PROJECT INFORMATION

site address	3405/3411/3417 Harbor Ave SW
parcel numbers	7987400130, 7987400140, 7987400150
project number	3034147-EG

10.0 DESIGN REVIEW RESPONSE | itemized response to EDG

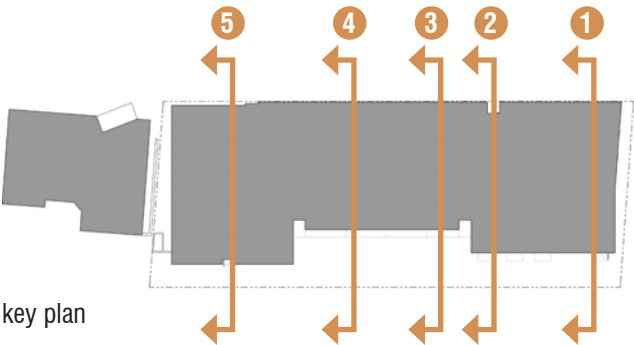
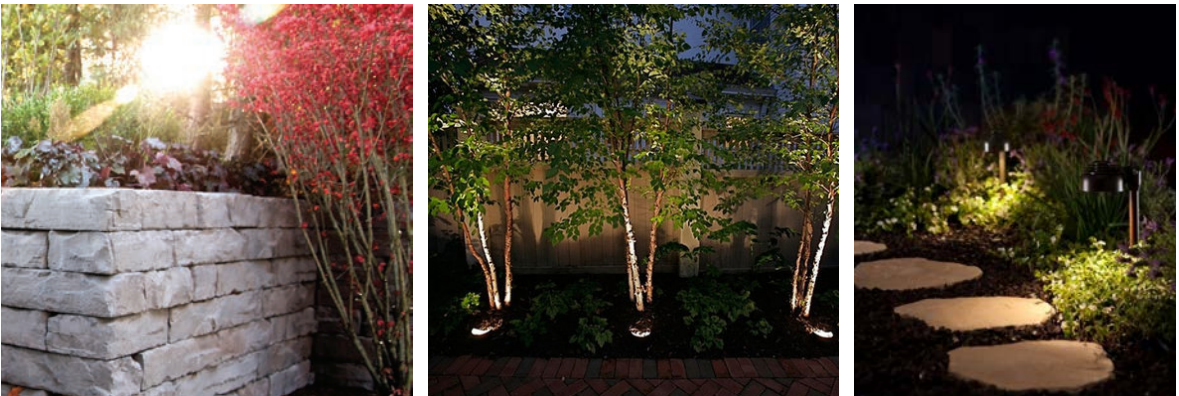
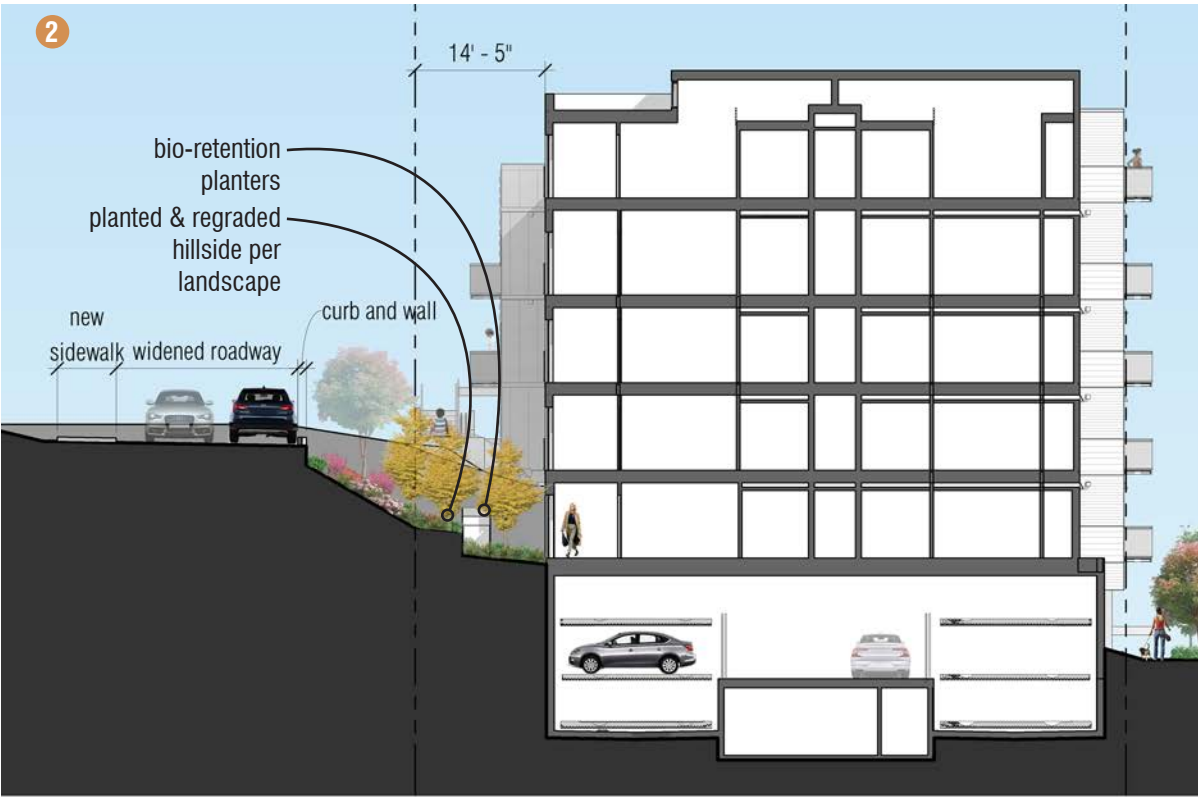
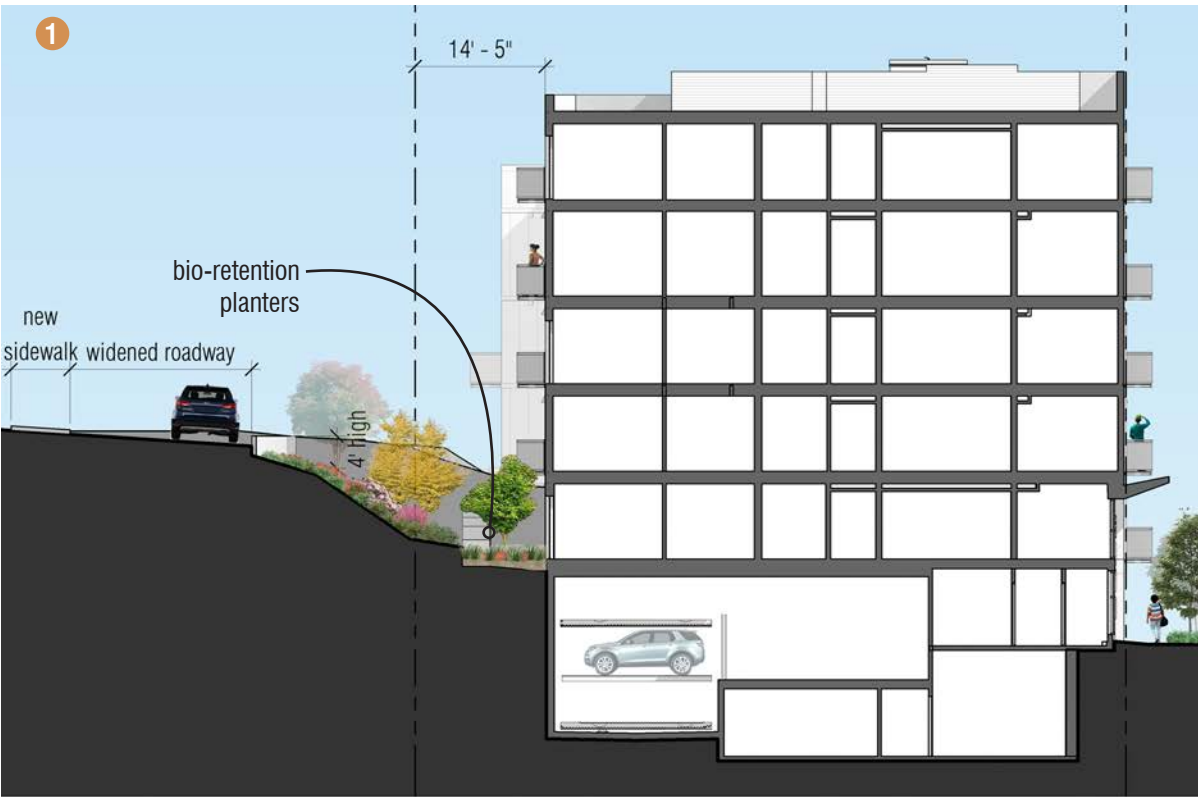
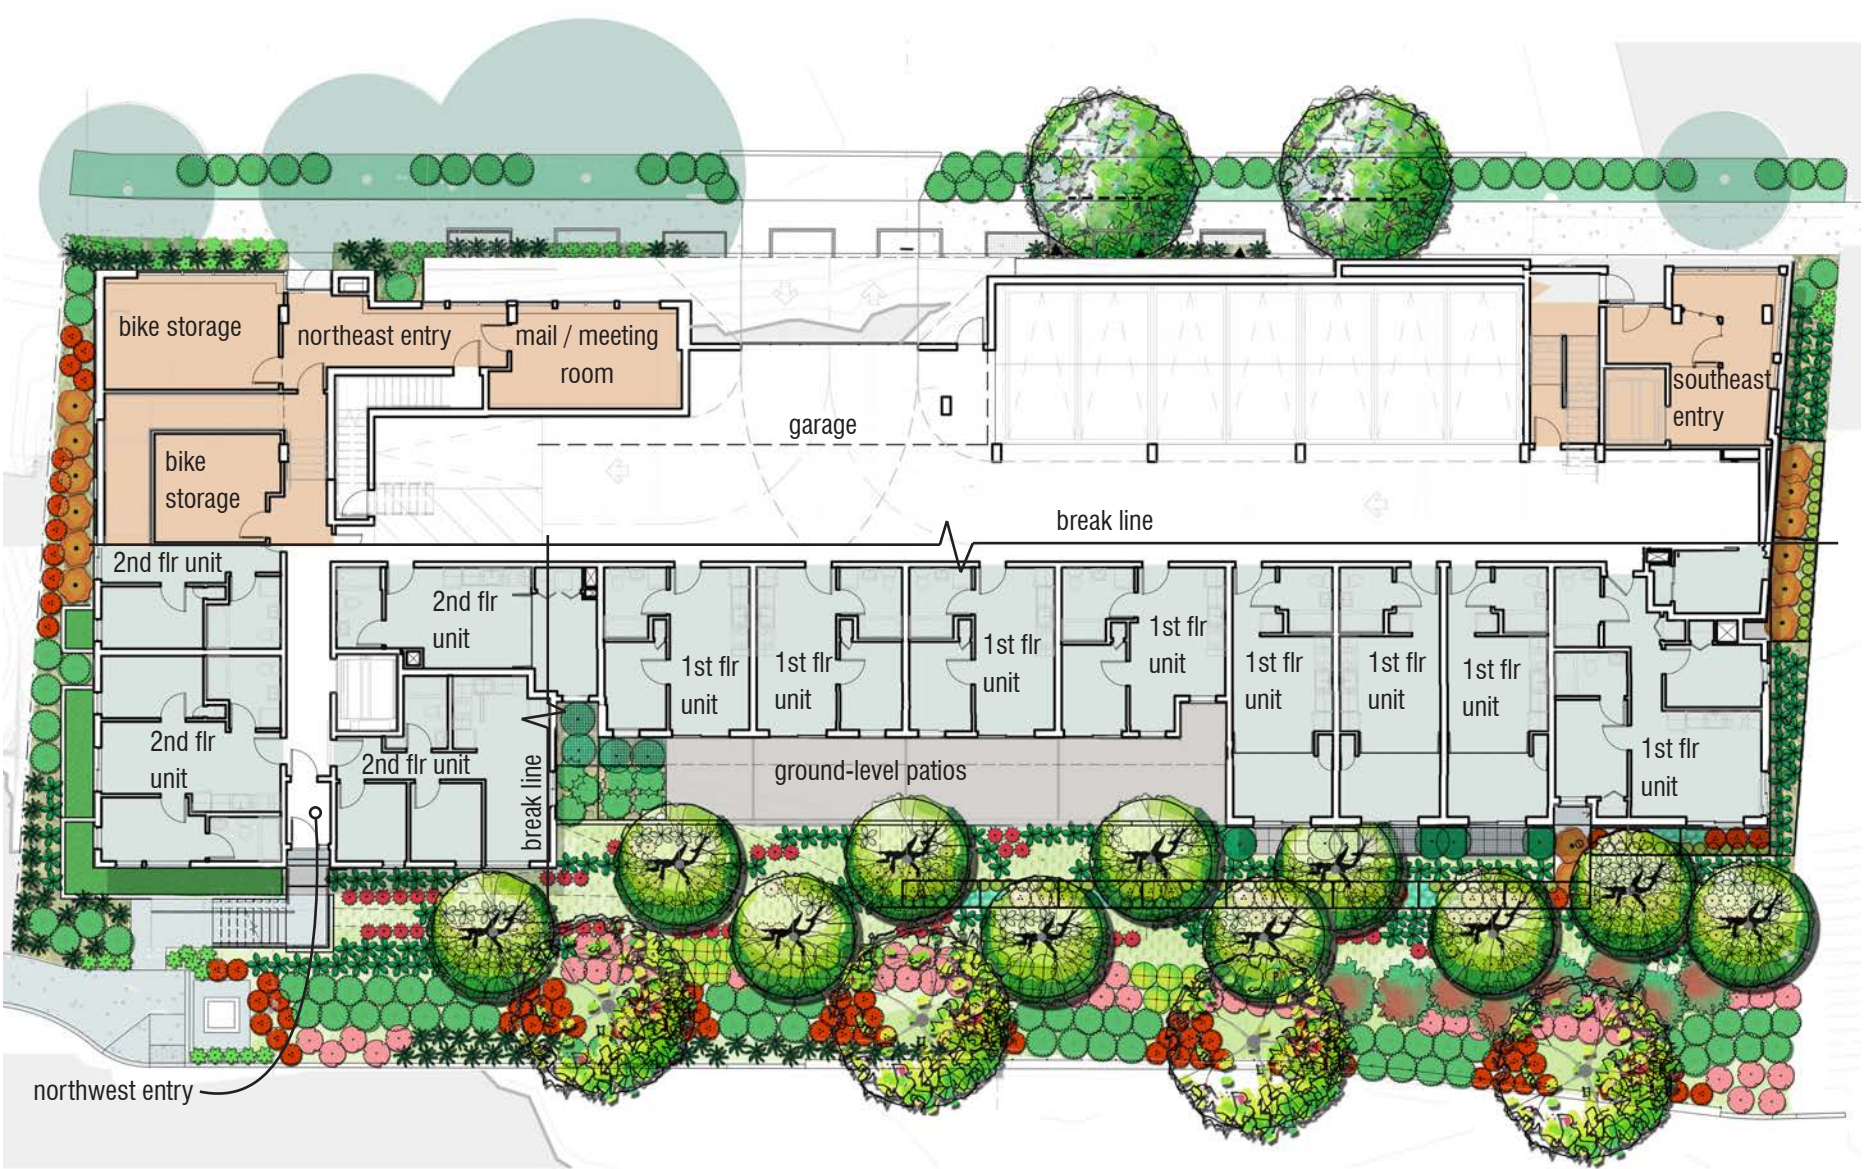
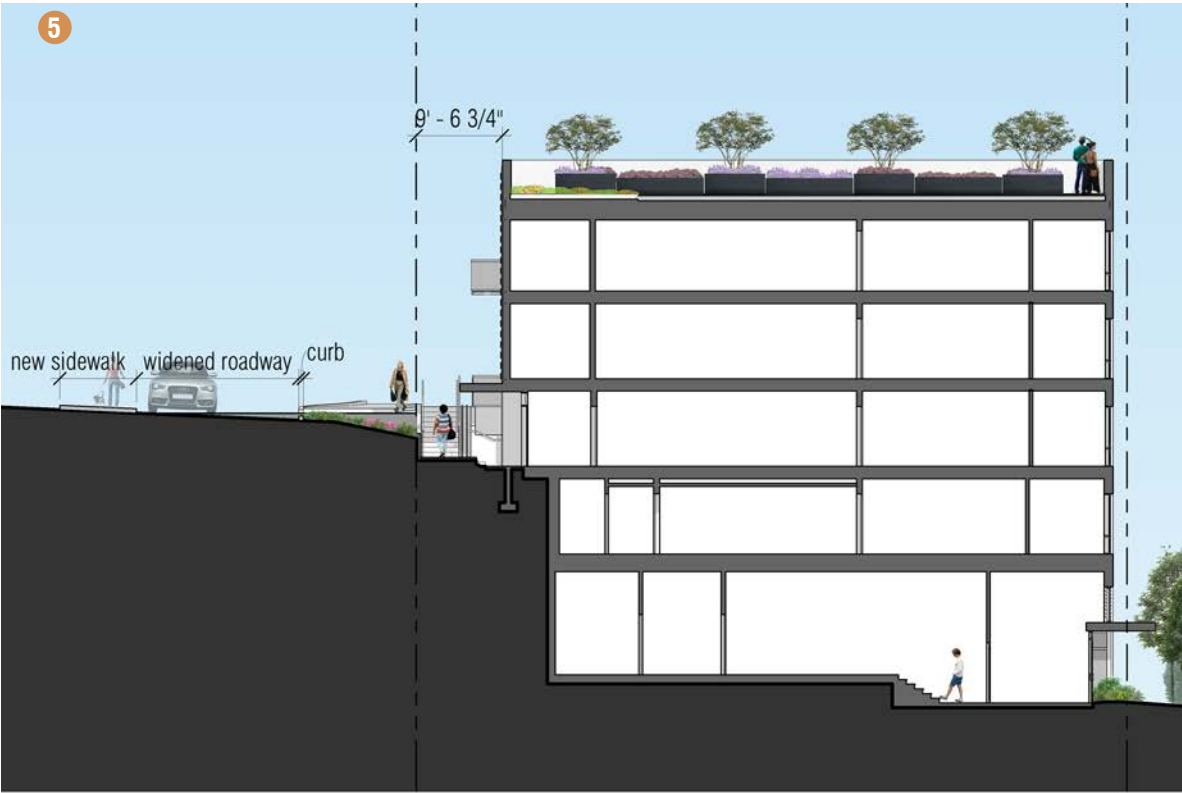
Landscaping - The Board appreciated the sketches and precedent images provided; however, the Board would like to see a more accurate depiction of relationship between the sidewalk and the project's courtyard and patios. In addition, explore how terracing and landscaping could be designed to create a more gradual transition along the steep slope (DC2-A1, CS1-C).

The slope along the western edge of the property slopes in multiple directions, with the steepest portions along at the north and south corners. Where possible, the slope has been re-graded in order to provide a more gradual transition, and the building has been sited in order to provide at grade connections at multiple levels.

- The new residential entrance on 30th Ave SW exits at grade, with a stair and runnel provided to connect to the street above. By locating this connection at the northwest corner, it takes advantage of the shortest elevation change along 30th.
- Planters and bio-planters help to terrace the slope, while providing additional privacy for neighbors and residents alike.
- Units at the courtyard exit directly on grade, and are able to connect via pathway to the hillside and stairs above.
- The landscape design along this façade continues to develop the terrace concept proposed at EDG, softening the hillside with layers of planting, adding texture and color for both the building's residents and neighbors to enjoy.
- The removal of the exceptional tree helps to accommodate the re-grading, improving the transition.

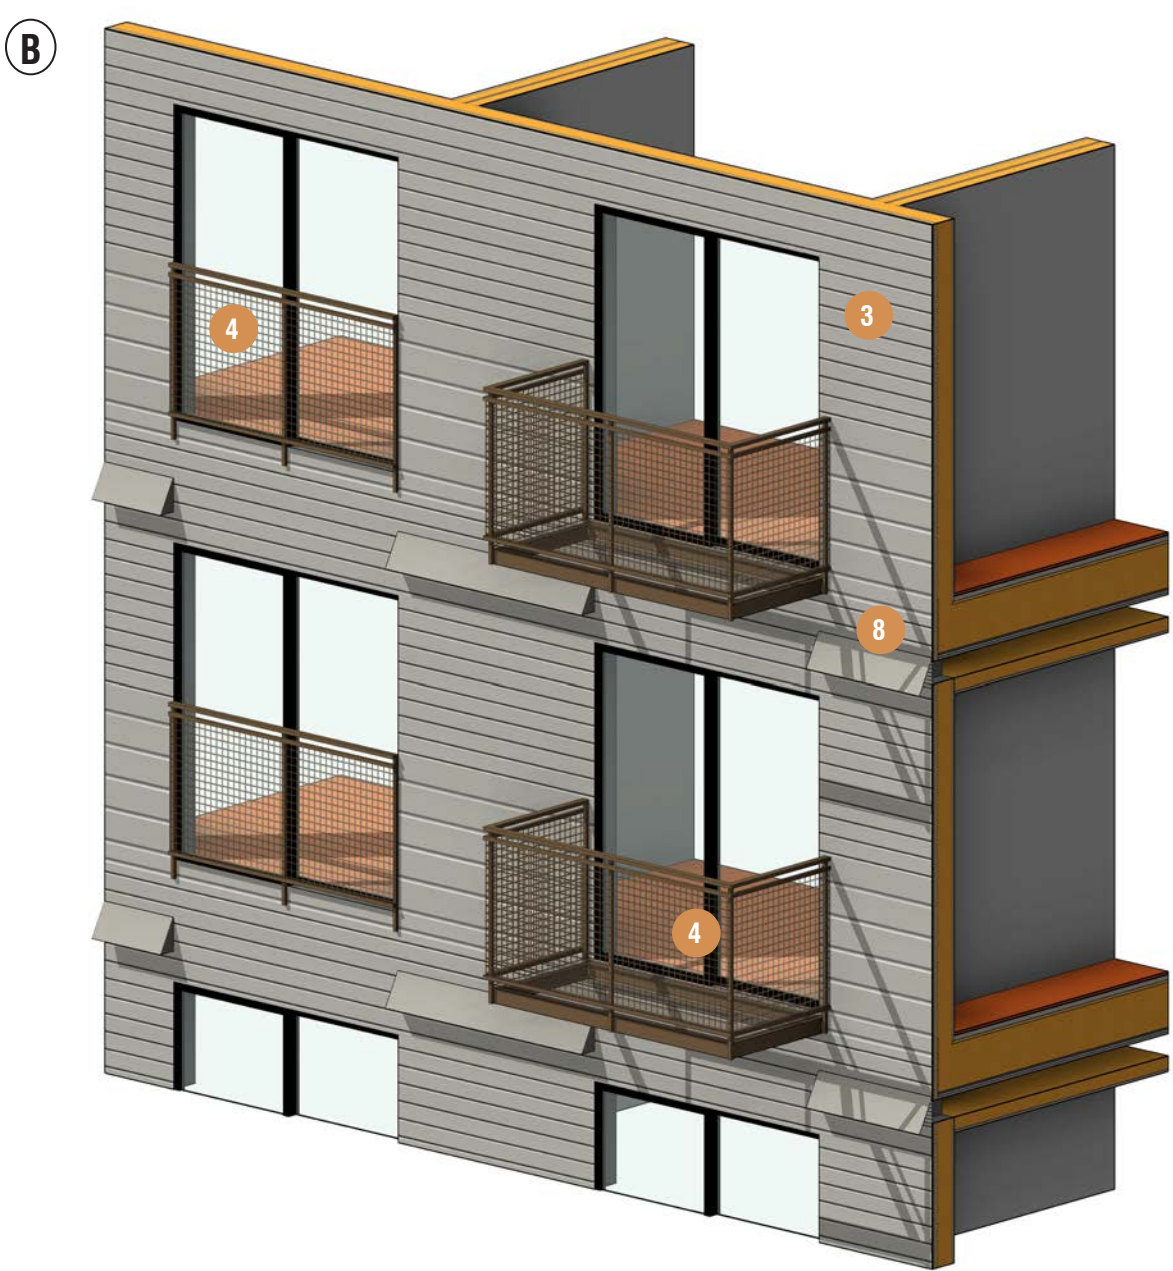
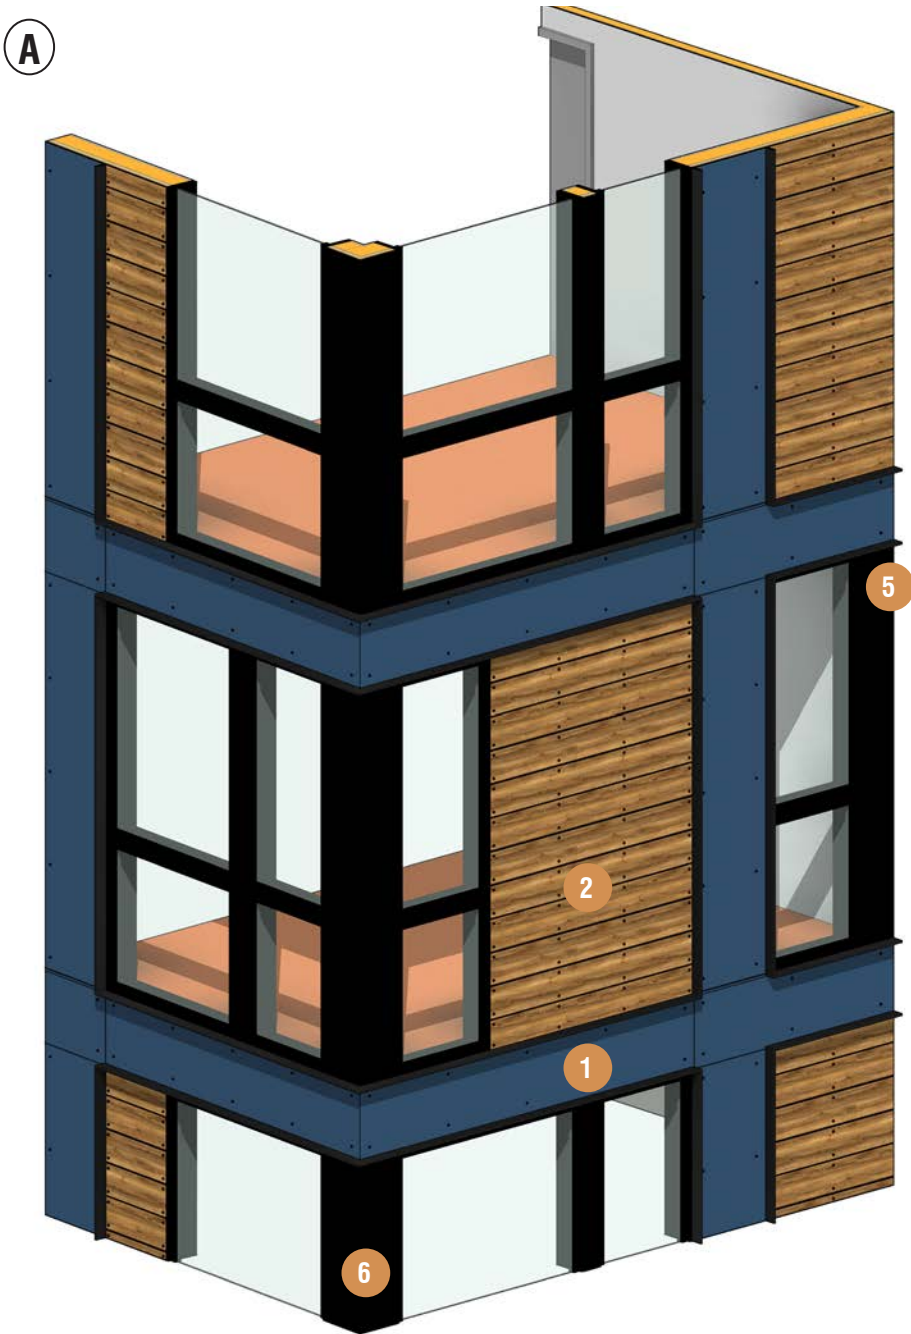
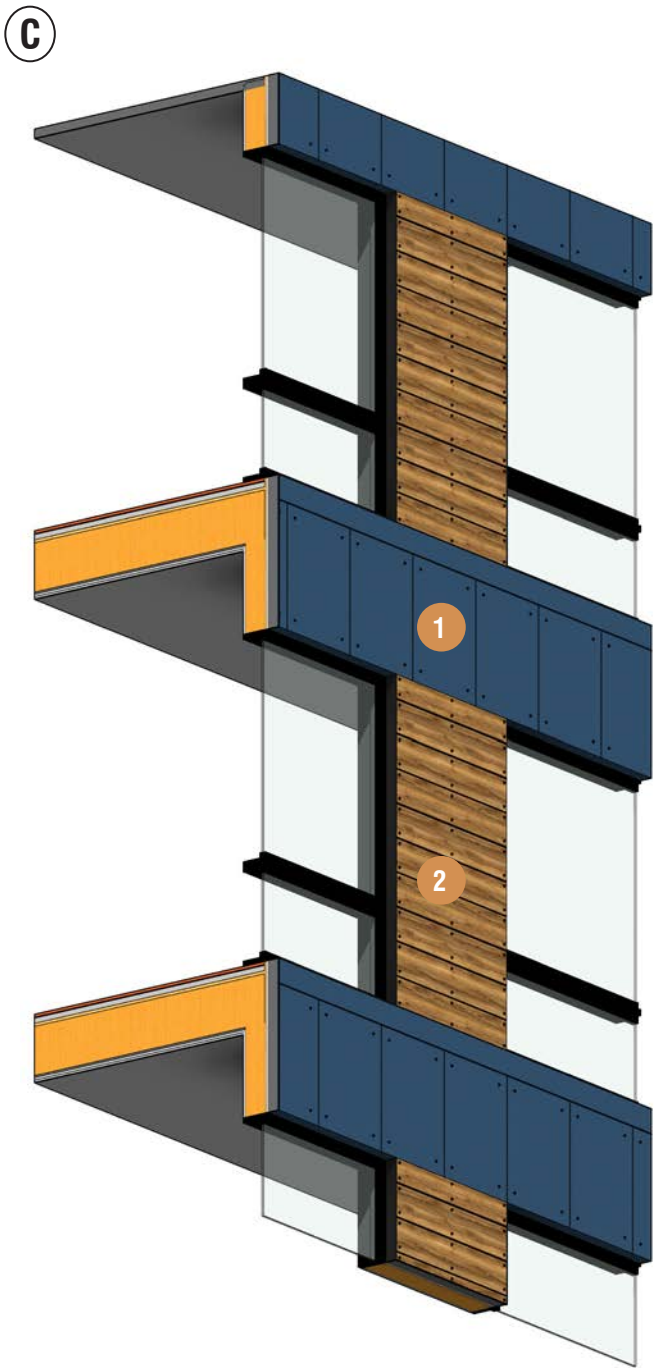
Materials - As noted above, the Board expects to see material application and detailing which further breaks down the height, bulk, and scale of the simple massing form (DC2-B1, DC2-C1, DC4-A1).

The project continues to explore material options and detailing to break down the building's massing. Regimented panel seams and a lively window pattern are used to create a playful expression at the north corner. The remainder of the north and south nodes uses the same material palette, but with an offset panel seam pattern and regimented windows and doors. At the center interlocking bar form, simple window patterns and plank siding quiet this center mass. The combination of horizontal and gridded balconies further reinforces the residential scale. The architectural expression of the north and south nodes are further distinguished from the center mass through the detailing.

- Windows and doors on the north and south node are recessed to provide an expression distinct from the center interlocking mass.
- Careful attention has been made to apply a logical panel seam rhythm to the windows, particularly at the southwest corner element where all windows and wood tone panels fit within the panel seams.

- The gaskets along Harbor Ave SW are fully expressed (without balconies disguising the change in plane) which contribute to a massing concept scaled appropriately to fit with the industrial and commercial zones it abuts. Alternatively, the gaskets along 30th Ave SW are connected to the longer balcony expression in response to the residential scale of the adjacent zone.

- The use of two sizes of lap siding helps to break up the mass and provide a residential scale.
